ENGINEERING CHANGE NOTICE
DART AEROSPACE LTD

Date: 19.03.07	Job No.: RB18-BELL	ADR Yes/No: N	ADR Date:	ECN #: 19- 572
Product No.: DART TOOLING BELL		Created By: VM	Approved By: VK	
Product Name: JET RANGER FIELD KIT		Checked By: mpp

Reason for Change:
ITEMS MISSING

RBT18510 REV L

RBE2-10-1 FUEL SYSTEM CARTRIDGE REMOVAL TOOL

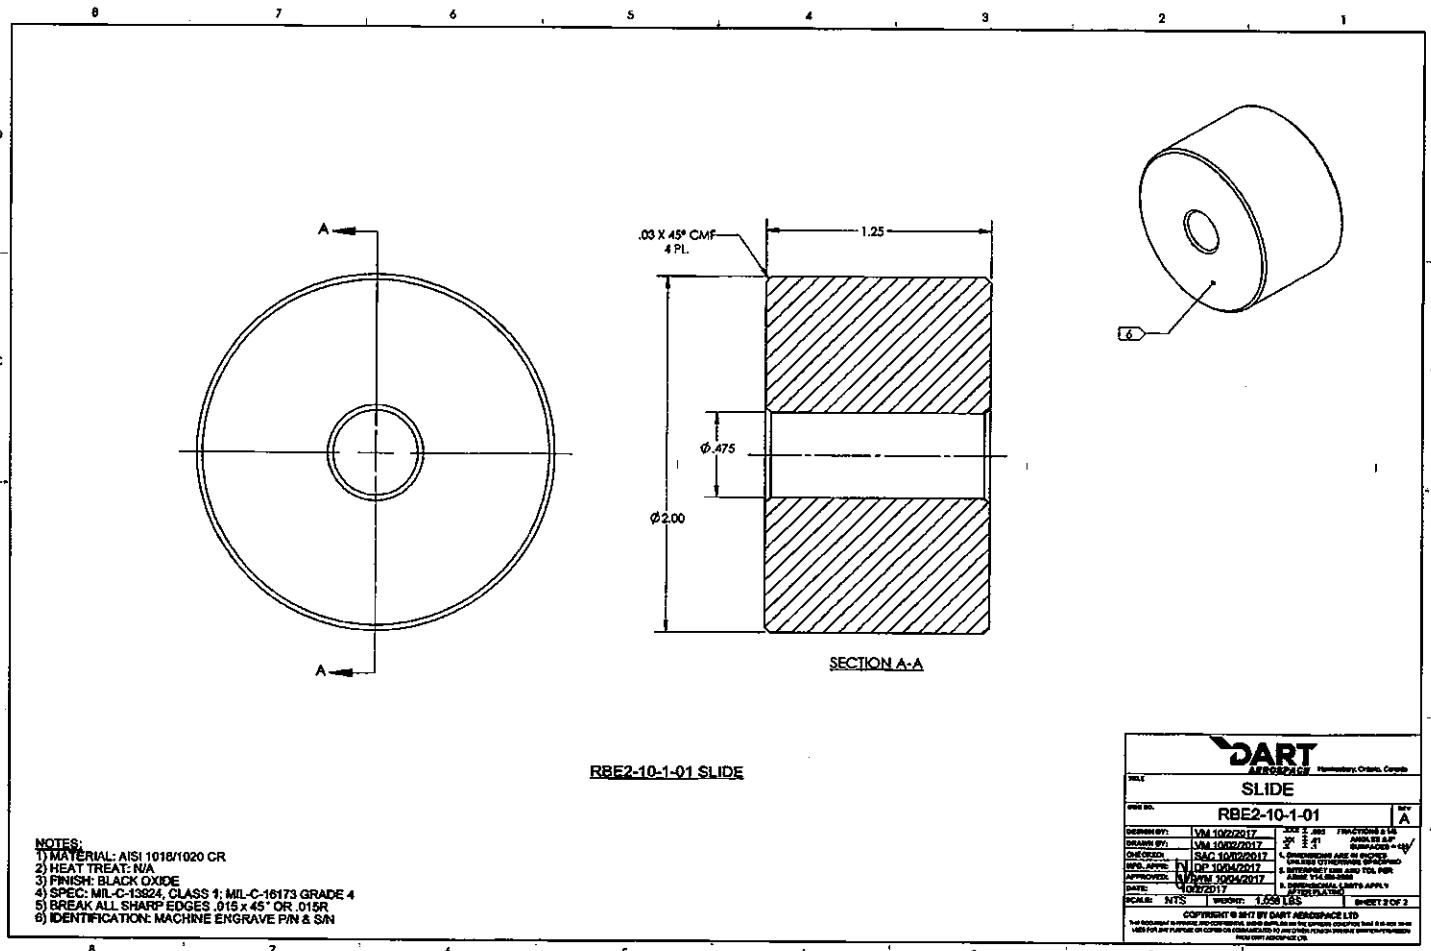
Details	Raised by customer support - Kit Part# RBT18561; RBE2-10-1 sub part has been damaged by the rivets in the top portion of pelican case. Its is also corroded. Found issue when inspecting RA570
---------	--

Type	Corrective Action
Number	3
Owner	Lacelle, Linda
Details	Re-work kits in quarantine- damaged part# RBE2-10-1 as soon as possible

RBE2-10-1 was damaged due to the missing top foam. So we will have to manufacture another one at Rev. A to replace it.
